GLOBAL SAFETY FIELD INVESTIGATIONS
DCS5796
URGENT - DISTRIBUTE IMMEDIATELY

Subject: N212329521 - Emission Recall
VECI Label Missing OBD Designation

Models: 2020 Cadillac CT4
2020 Cadillac CT5

N212329521 VECI Label Missing OBD Designation

5813383

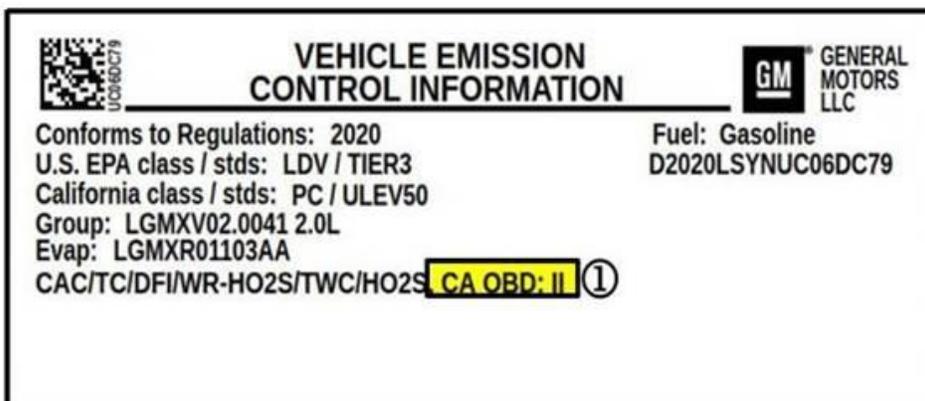
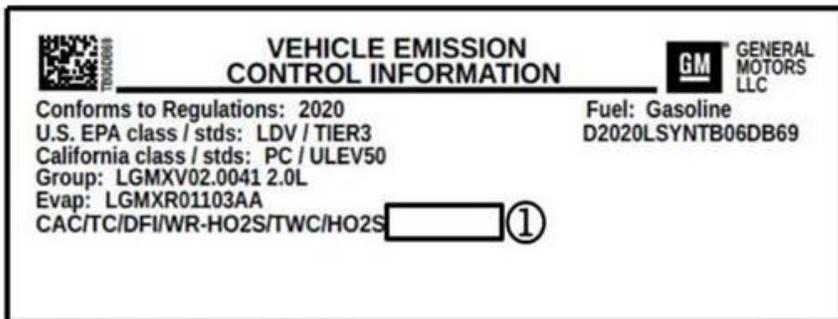
2. Locate the Vehicle Emission Control Information (VECI) Label on the underside of the hood, in the location shown by the arrow.

3. Clean and dry the VECI label on the underside of the hood using water and a clean, lint-free cloth. The surface must be clean, dry, and free of any contaminants.

4. Affix the new Vehicle Emission Control Information Label overlay onto VECI label in the spot specified (1).
5. Close the hood.
